## RESOLUTION 14-R-03

### A RESOLUTION TO AMEND THE TOWN OF FELTON CONSTRUCTION STANDARDS AND SPECIFICATIONS

DRIVEWAY / APRON  
ENTRANCES

DRAWING: D4-3

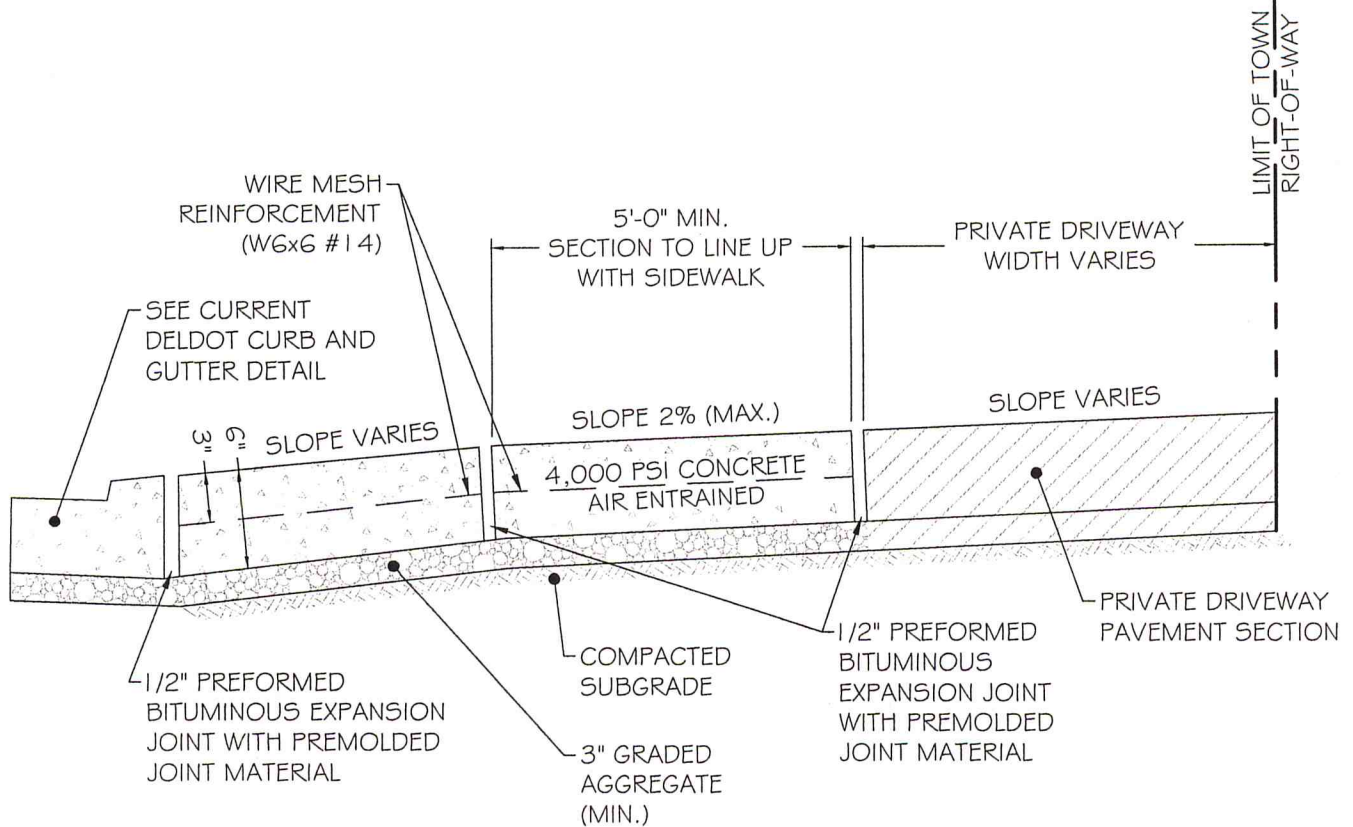
**Section 1.** Section 4.04.A. of the "Town of Felton Construction Standards and Specifications" shall be amended to delete 2) and replace with new section which shall read as follows:

2) Driveways/apron entrances shall be constructed to a minimum thickness of six (6)-inches within Town right-of-way and shall be reinforced with six (6)-inch by six (6)-inch, w/1.4 c w/14 wire mesh or concrete shall contain an adequate mixture of fiber mesh.

See Exhibit A, attached hereto.
